Cherrywood Pointe of Bloomington

5501 American Boulevard W.
Bloomington, MN 55437

Project Number	17058
Date	8.7.19 - Permit Set
Drawn By	Author
Checked By	Checker

PL201900139
PL2019-139

Site Plan

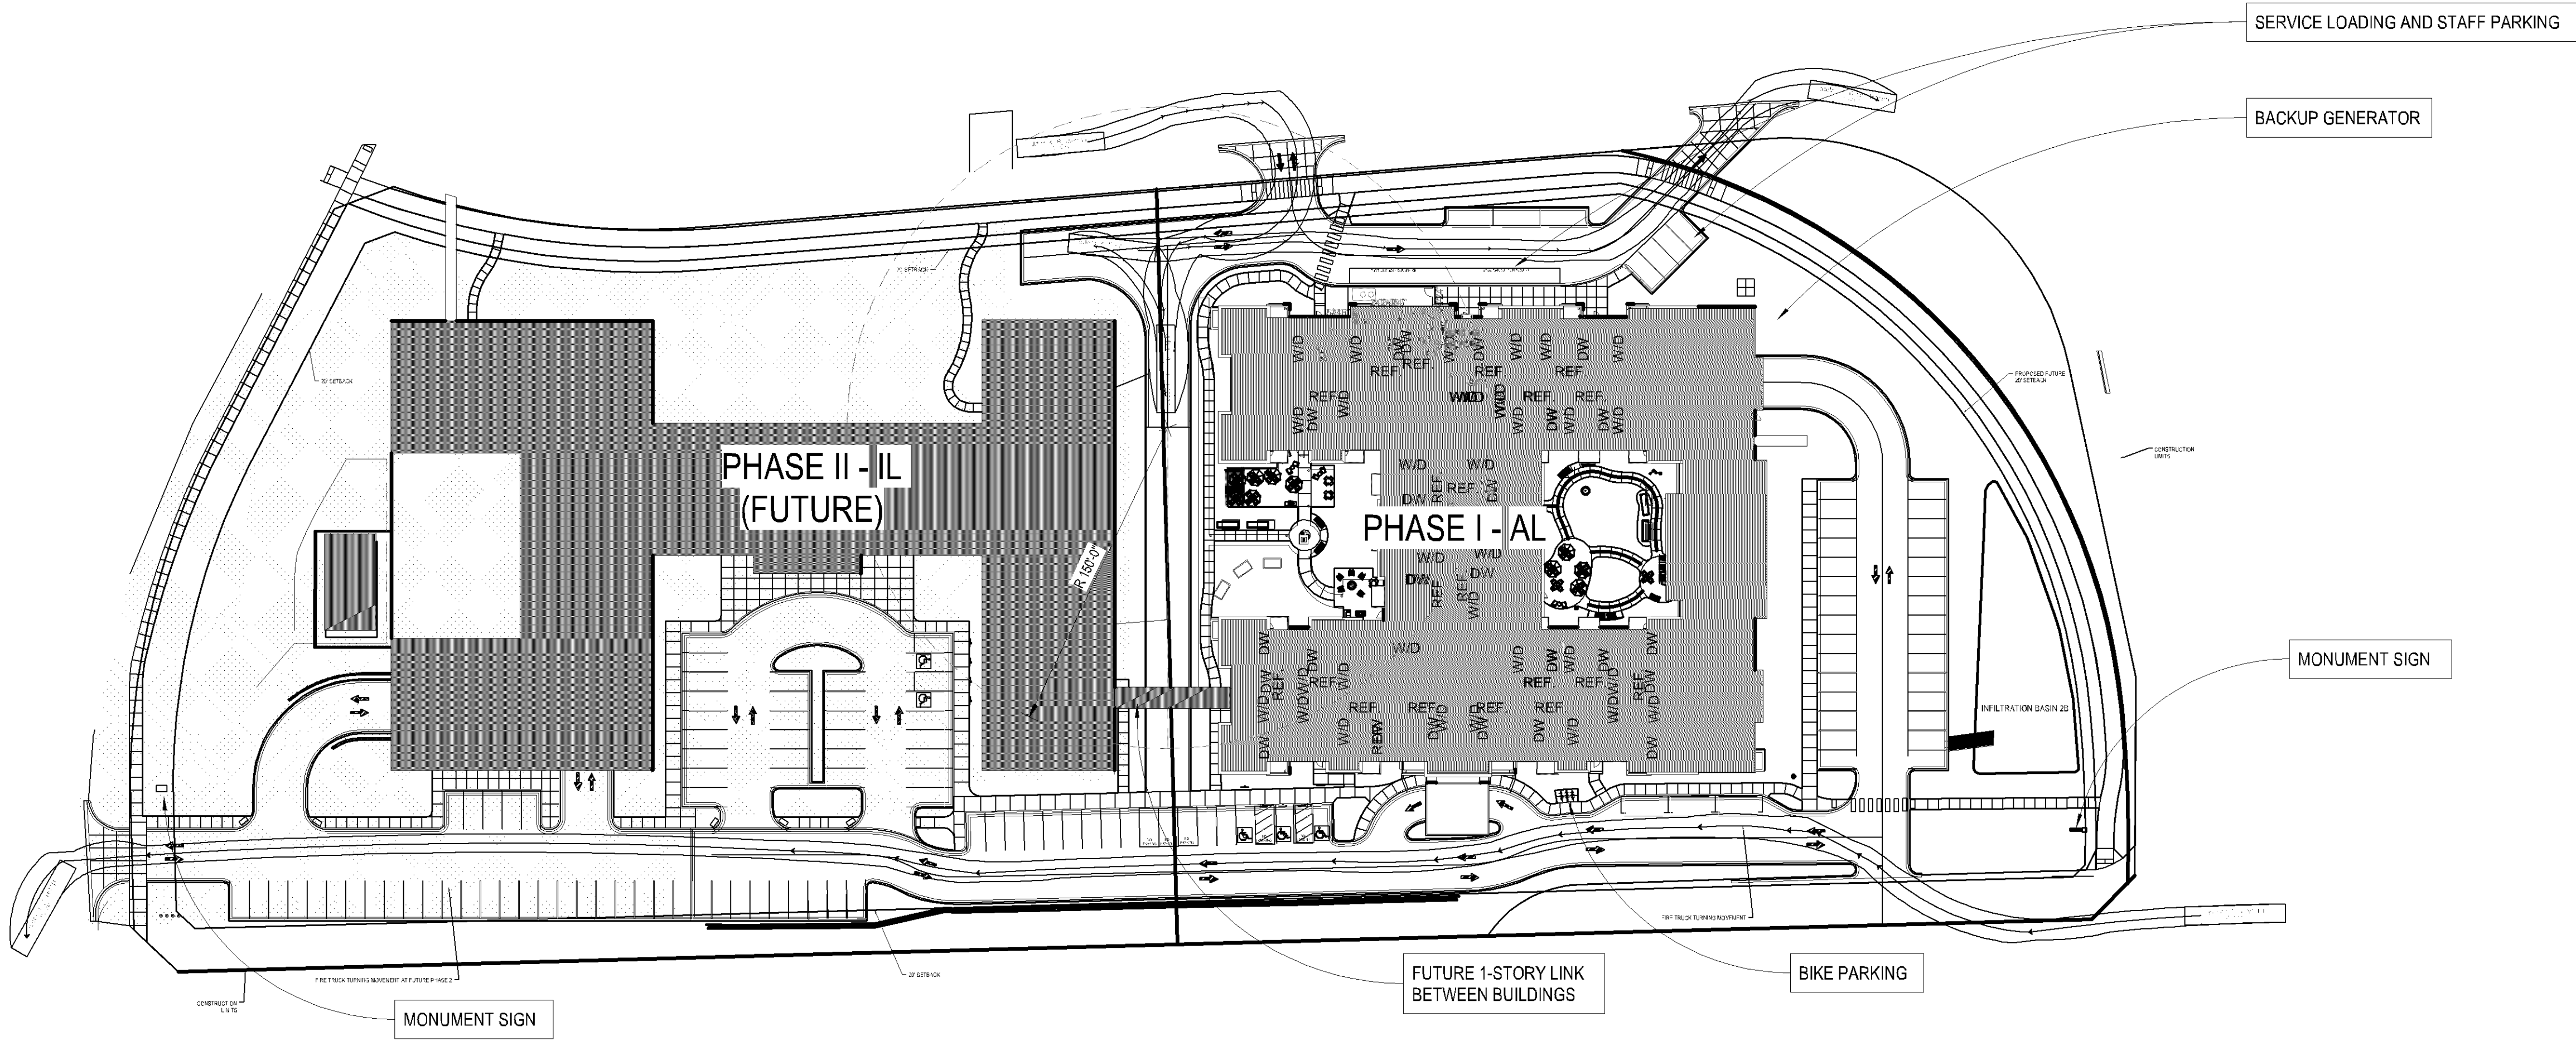
Hydrant coverage shall be provided within 50' of the FDC and within 150' of all portions of the structure.

Emergency responder radio coverage meeting the requirements of appendix L in the 2015 MSFC shall be provided throughout the property and within the structures.

Level -1

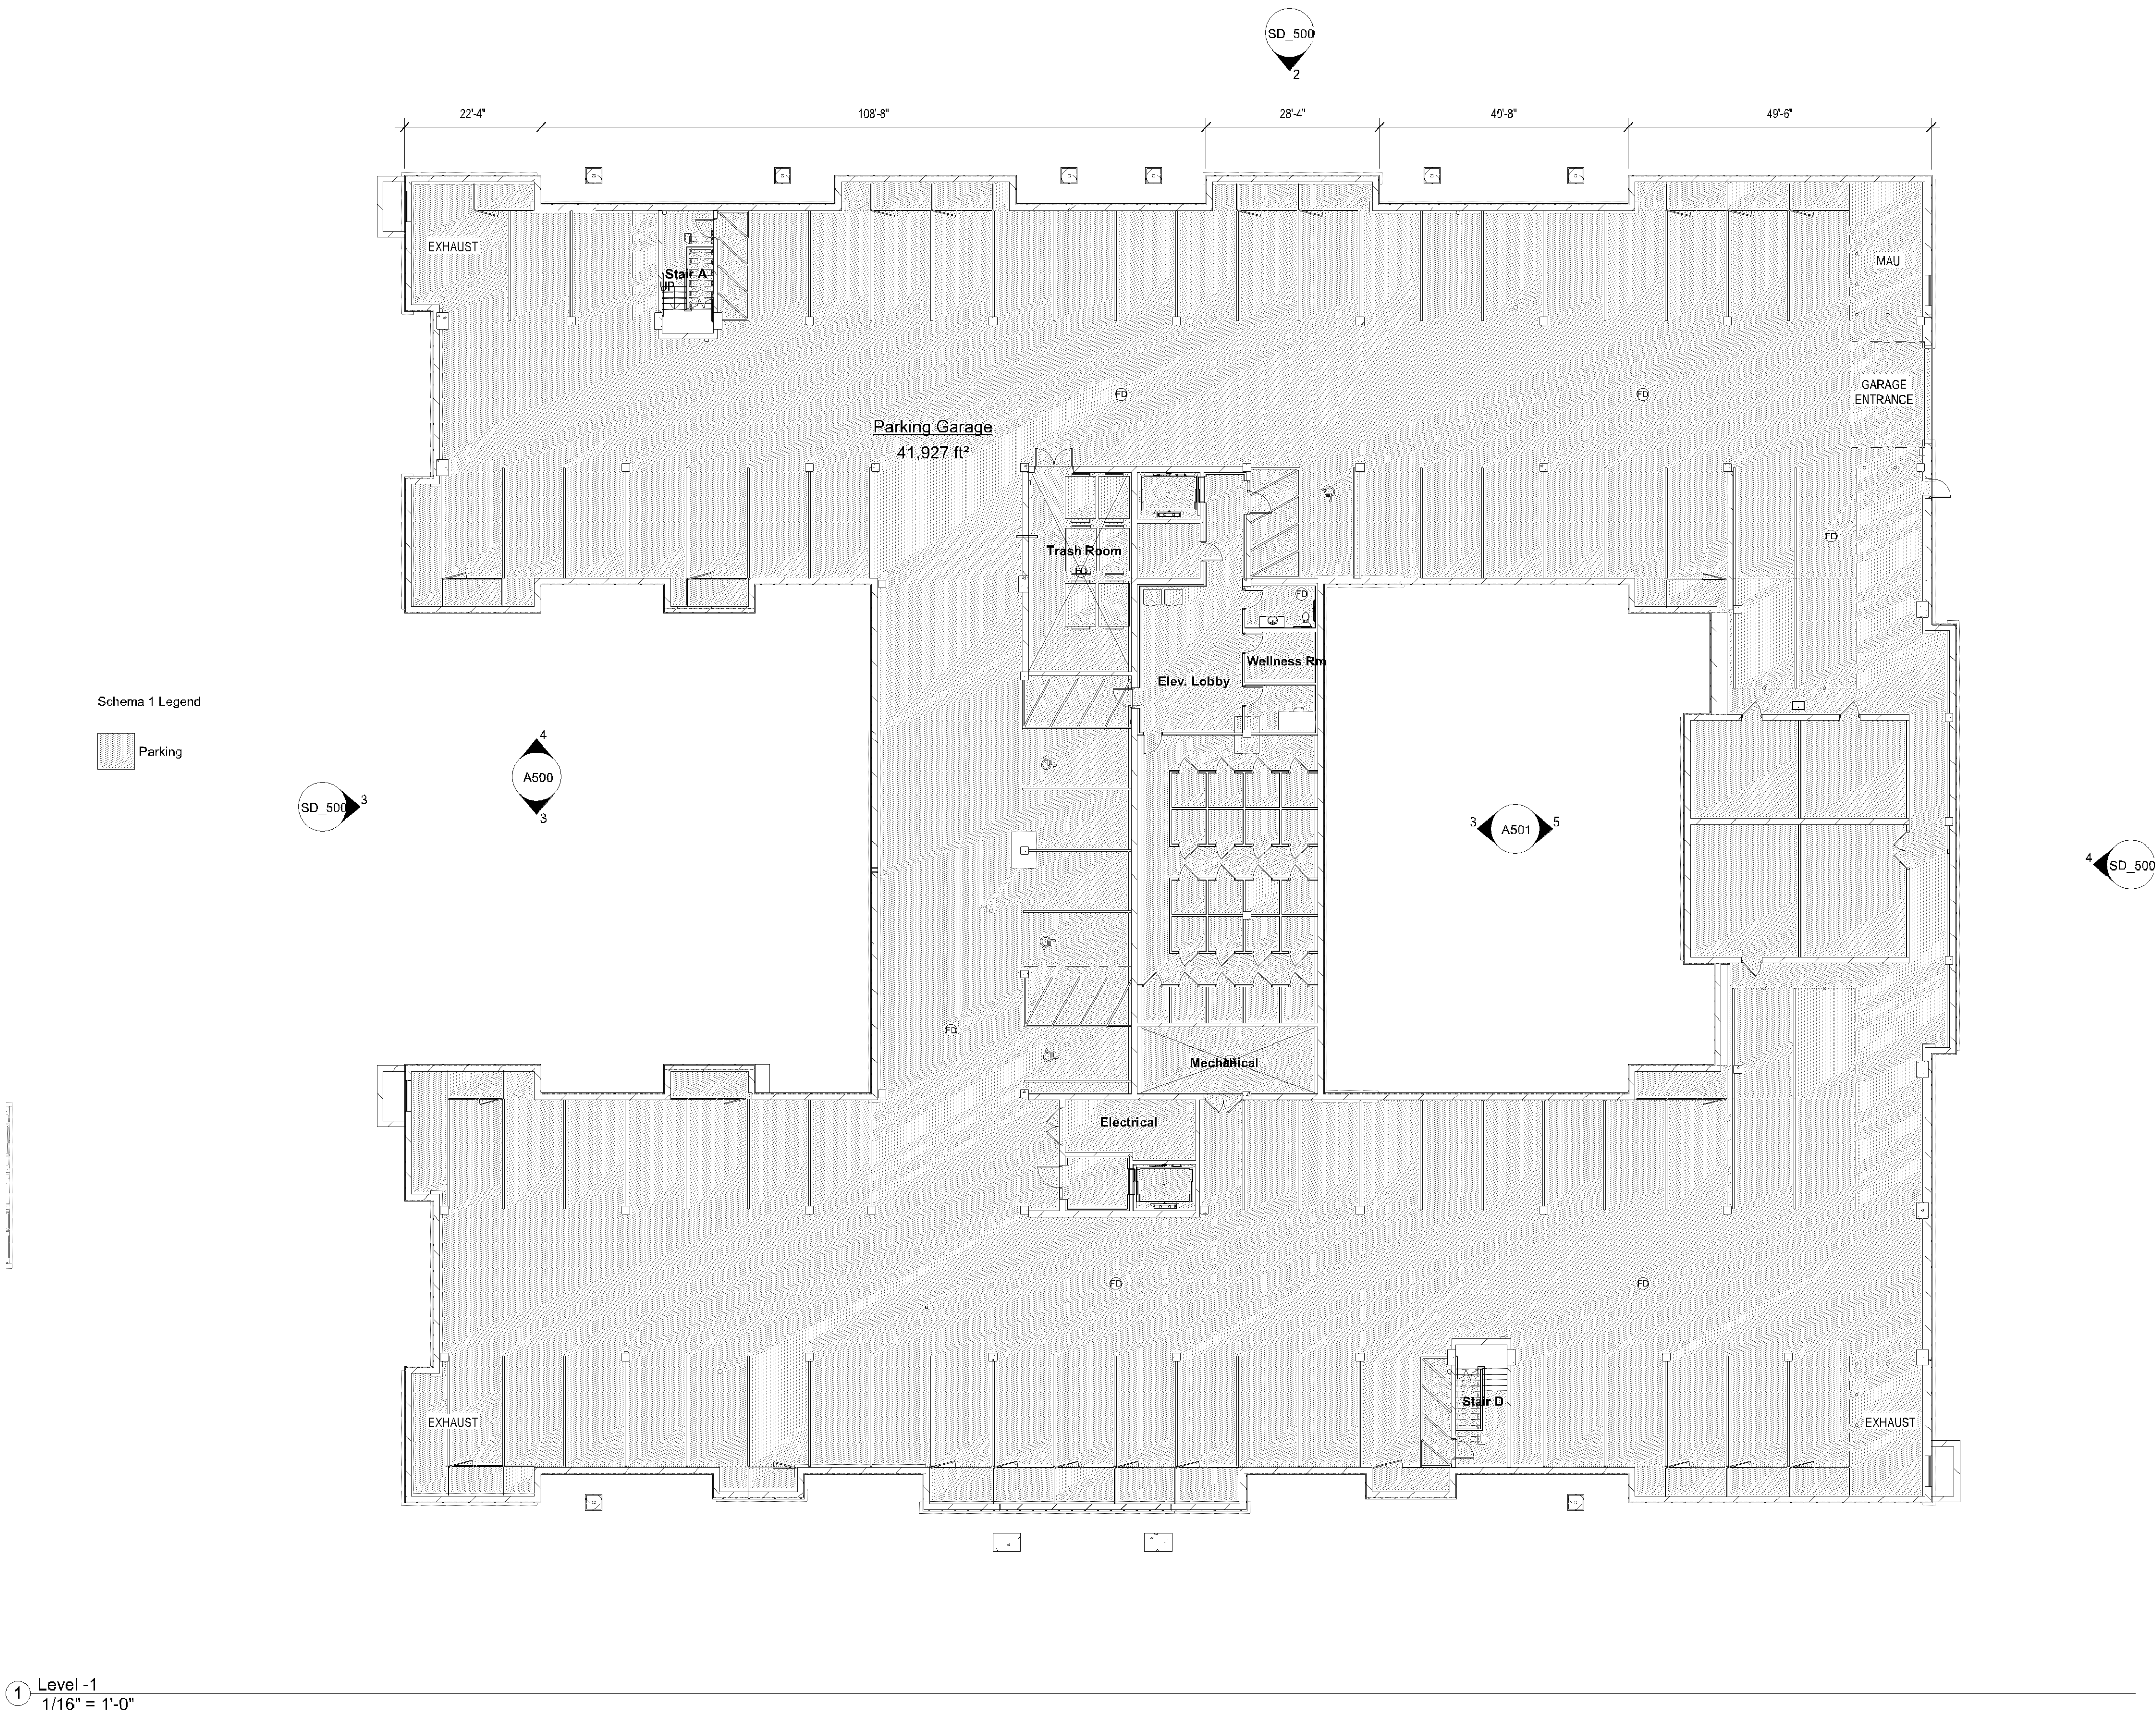
Hose valves shall be provided throughout the lower level of the parking garage within 130' of all areas of the garage if dry standpipe or within 200 feet if installing a wet standpipe
